# TECHNICAL BULLETIN

NO. 200-003                      DATE September 20, 1976                      (SUPERSEDES NO.                      )  
REV.                                      DATE    (SUPERSEDES NO.                      )  
REASON

SUBJECT	:	Procedures for Flap Control Cable Adjustment.
AIRCRAFT AFFECTED	:	FA-200 series airplanes S/N's 12 thru 243. (The subject procedures are contained in the service manual 200-010013 delivered with airplane S/N 244 and sub.)
PRIORITY	:	Desirable
REASON	:	To clarify the existing adjustment procedures described in the Service Manual 200-010003A. Adjustment in compliance with these procedures eliminates requirement for cable tension measurement.
DESCRIPTION	:	This technical bulletin supersedes the Service Manual 200-010003A, Para 8-3-3 Adjustment of Flap System, in its entirety.
ACCOMPLISHMENT	:	Any time when flap cable is checked or adjusted.
APPROVAL	:	Not applicable
PARTS REQUIRED	:	None required
SPECIAL TOOL	:	None required
WEIGHT AND BALANCE	:	No change
REFERENCE	:	None
DETAILED DESCRIPTION	:

FIG. 1 FLAP SYSTEM

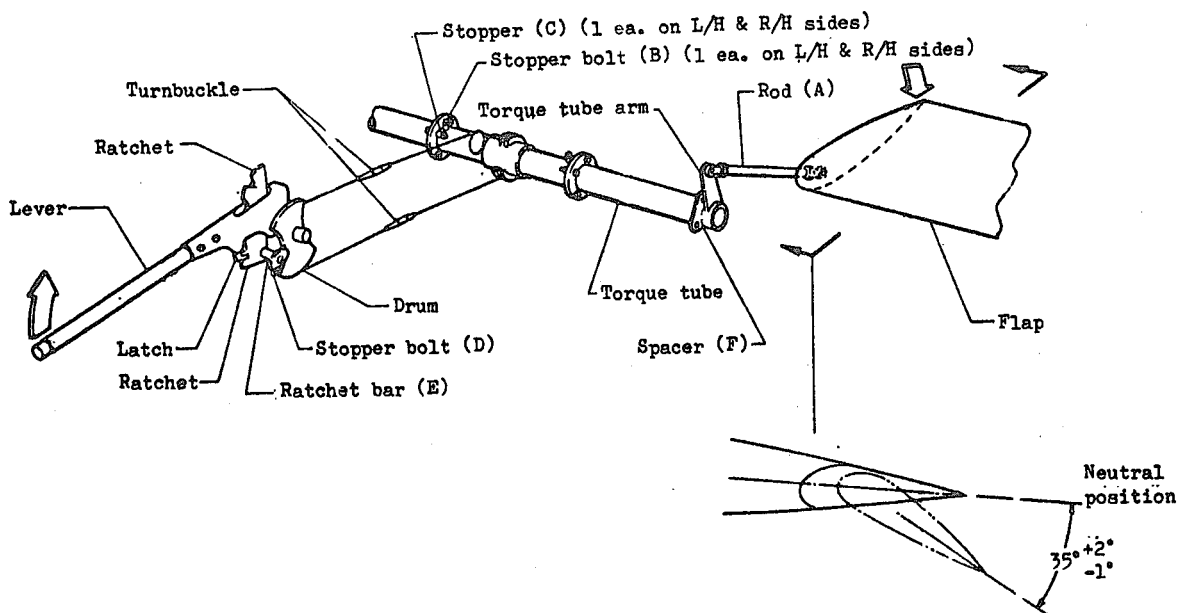
(1) Engage lever latch in the lowest groove of ratchet and hold lever in this position.
		(2) Connect torque tube arm and flap with rod (A).
		(3) Adjust upper cable as follows:

a. Stretch cable until two stopper bolts (B) contact stopper bolt (C), and further stretch cable by rotating turnbuckle half to one and half turns.
		b. Set flap in neutral position by adjusting connecting rod (A).

- (4) Adjust lower cable as follows:
- a. Stretch cable until two stopper bolts (B) contact stopper bolts (C) lightly.
- (5) Raise lever to engage lever latch in the upperest groove of ratchet. Hold lever in this position and adjust bolt (D) so that it contacts ratchet bar (E). Check to ensure that flaps are positioned in "DN  $35^{\circ} +2^{\circ} -1^{\circ}$ ".
- (6) Secure turnbuckle with clip (MS21256-1) or safety wire.
- (7) After completion of adjustment, if flap "play" is noted when flap is position in neutral, bond rubber (P/N 200-1600001) to flap outboard hinge as necessary.
